## REMARKS

**APPENDIX 1: Annotated Sheet 1/6**

**AMENDMENTS TO THE DRAWINGS**

FIG. 1B

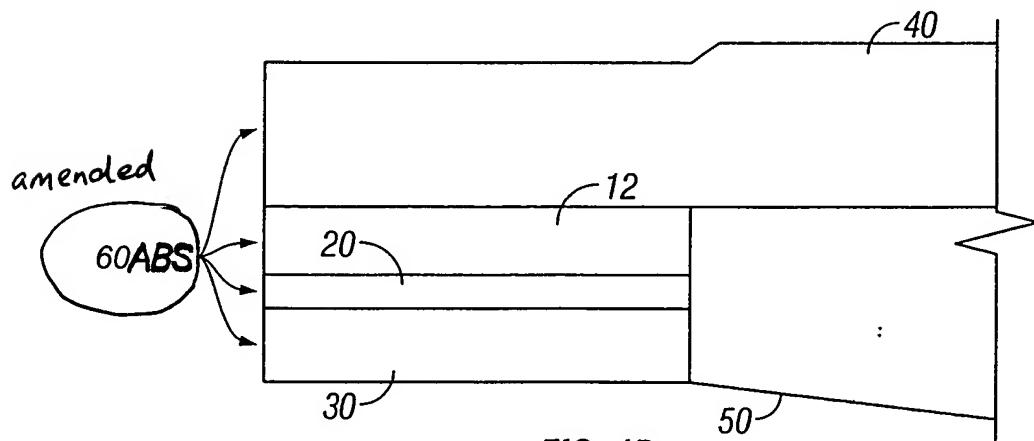
The first objection addressed the fact that sheet 1/6 includes a reference character (“44” in Fig. 2) that was not mentioned in the description. The second objection (from the most recent Office Action for related divisional application 10/317,878) noted that reference numeral “60” is used to reference both an ABS [i.e., air-bearing surface in FIG. 1B] and a GMR active device [i.e., a giant magneto-resistive or an AMR, i.e., anisotropic magneto-resistive, active device in FIGS. 4A & 4B].

In FIG. 1B of drawing sheet 1/6, please add “ABS” to reference numeral “60” and delete reference numeral “44.”

Concerning the second objection (from the most recent Office Action for related divisional application 10/317,878), applicants respectfully maintain that this objection has been overcome by amending the specification (e.g., replacing paragraph 0042) and the drawings (e.g., submitting replacement sheet 1/6) so that the air-bearing surfaces of FIG. 1B are indicated by numeral “60ABS.” The reference number for the air-bearing surfaces of FIG. 1B (i.e., “60ABS”) is distinct from the reference number for the GMR active devices of FIGS. 4A & 4B (i.e., “60”).

An annotated version of FIG. 1B with the changes indicated in red ink is attached in Appendix 1 along with a replacement sheet for drawing sheet 1/6 in Appendix 2.
